Southern Nuclear Operating Company
Vogtle Electric Generating Plant Units 3 and 4
Request for License Amendment and Exemption:
Changes to Containment Cooling and Spent Fuel Pool Makeup Strategies (LAR-17-021)

Vogtle Electric Generating Plant (VEGP) Units 3 and 4

Changes to Containment Cooling and Spent Fuel Pool Makeup Strategies

(LAR-17-021)

Figure 1 – Spent Fuel Pool & SFP Safety-Related Makeup Sources

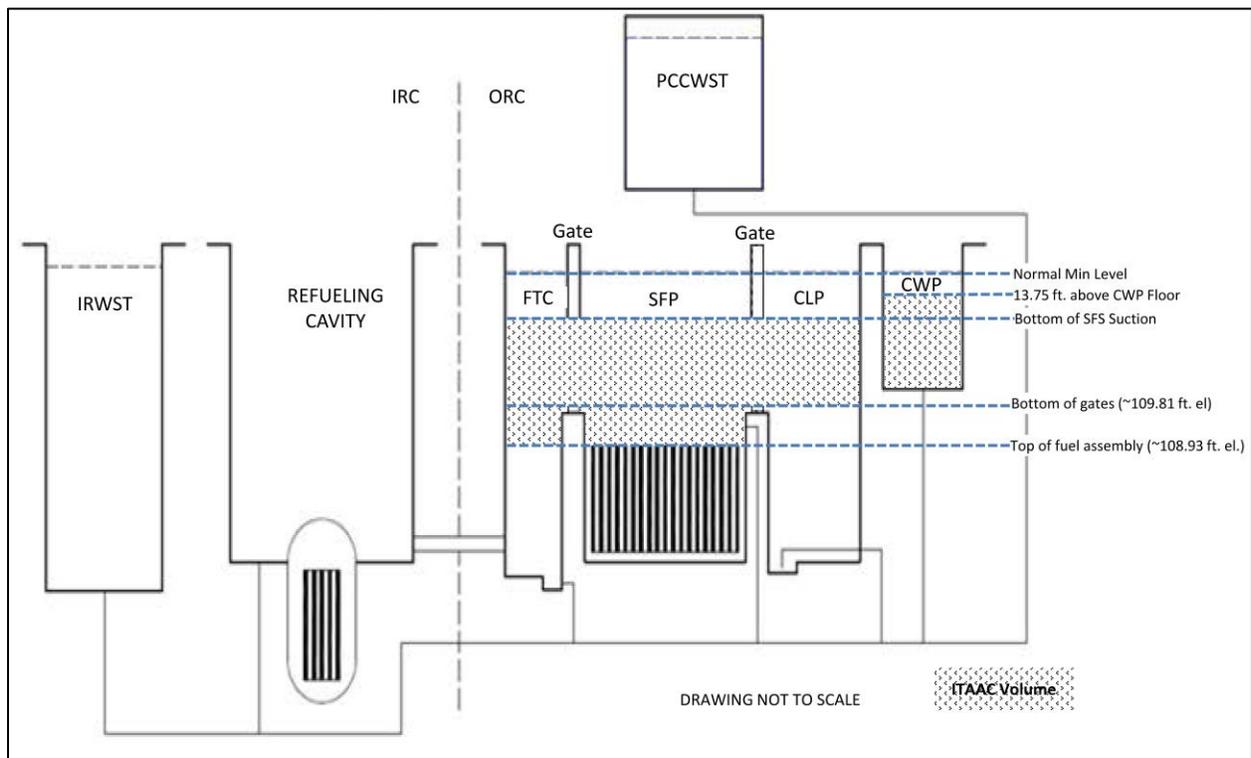
This amendment request, in part, proposes to redefine the TS 3.7.9 SFP decay heat limits identifying the conditions when the safety-related SFP makeup sources must be available, based on a revised SFP heatup and boiloff analysis. The proposed redefinition of these limits is to account for an additional loss of SFP water following the postulated design basis event, as a result of conditions not previously considered in the SFP heatup and boiloff analyses. Specifically, following the SFP cooling design basis event and subsequent draindown of the SFP and safety-related makeup sources to the bottom of the SFS suction piping attachment to the SFP, the subsequent heatup of the SFP water would result in a pool swell due to thermal expansion and the formation of steam bubble voids as the pool begins to boil. This pool swell would result in an additional loss of water inventory through the SFS suction piping attachment to the SFP subsequent to the initial draindown of the SFP and safety-related makeup sources following the SFP design basis event. Accordingly, the SFP heatup and boiloff analysis was revised to account for the additional loss of SFP safety-related makeup water resulting in revised decay heat limits for the supporting makeup volumes.

The proposed ITAAC changes are due to a re-evaluation of the SFP, FTC, CWP, and CLP volumes in the revised SFP heatup and boiloff analysis, the addition of the volumes in the gate areas between the SFP and the FTC and between the SFP and the CLP, consideration of construction tolerances, and revision of the reference locations for the specified volume. An illustration of the ITAAC volumes that comprise the SFP safety-related makeup sources is

shown in Figure 1 above. Note that as discussed above, the PCCWST volume is not credited for SFP makeup if the reactor decay heat is > 7.0 MWt. Corresponding changes are proposed to UFSAR Table 9.1-2.

Figure 2 – ITAAC Volumes of Spent Fuel Pool & SFP Safety-Related Makeup Sources

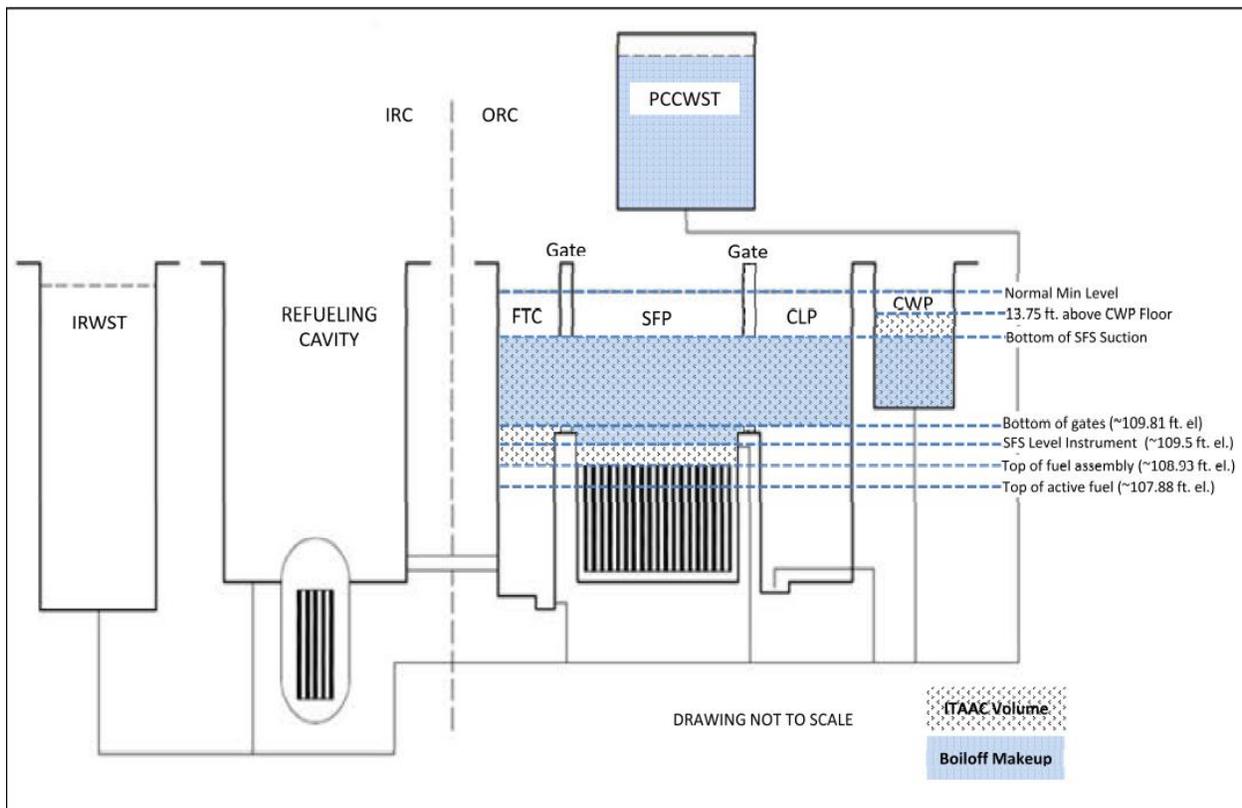
The revised SFP heatup and boiloff analysis discussed above continues to be conservative even following consideration of the loss of SFP and SFP safety-related makeup water inventory and supports the associated ITAAC volume changes. The ITAAC volumes were determined by establishing known reference points, while conservatively taking into account construction tolerances (i.e., increasing or reducing the relevant dimension to reduce the available water volume). The upper and lower elevations for each of the ITAAC measurement reference points were selected to be relevant to the spent fuel decay heat removal analysis.

The CLP lower elevation is based on the elevation of the gate between the CLP and SFP, which is the lowest elevation that CLP water can flow into the SFP. The CWP upper elevation is specified to be consistent with the existing Technical Specification 3.7.9 requirement. The CWP lower elevation is specified to be the CWP floor since its total contained volume would be available for SFP makeup. Figure 2 below illustrates the ITAAC volumes as proposed vs. the volumes credited in the analysis for boiloff makeup.

The length and width of the different volumes (wall locations) accounted for the construction tolerances specified in the design to establish conservative water volumes. The revised SFP heatup and boiloff analysis applied the construction tolerances specified in the design to establish conservative volumes of SFP makeup water. Accordingly, the volumes used in the revised SFP heatup and boiloff analysis are conservative, and support the ITAAC reflected in this change.

Table 2 Tier 1 Table 2.3.7-4 ITAAC Item 7.b) Changes		
ITAAC	Volume	ITAAC Changes
Item 7b.i)	SFP & FTC	Revised as follows: The volume of the spent fuel pool, and fuel transfer canal, <u>and both gate areas</u> above the fuel assemblies and to the elevation 6 feet below the <u>spent fuel pool cooling suction piping operating deck</u> is greater than or equal to <u>130,350</u> 129,500 gallons.

Item 7b.ii)	CWP	Revised as follows: The water volume of the cask washdown pit <u>from the cask washdown pit floor to 13.75 feet above the cask washdown pit floor</u> is greater than or equal to <u>34,100</u> 30,900 gallons.

Item 7b.vii) (new)	CLP	New ITAAC as follows: <u>Inspections, Tests, and Analyses</u> <u>vii) Inspection will be performed to verify the cask loading pit includes a sufficient volume of water.</u> <u>Acceptance Criteria</u> <u>vii) The water volume of the cask loading pit above the bottom of the gate and below the spent fuel pool cooling suction piping is greater than or equal to 46,050 gallons.</u>
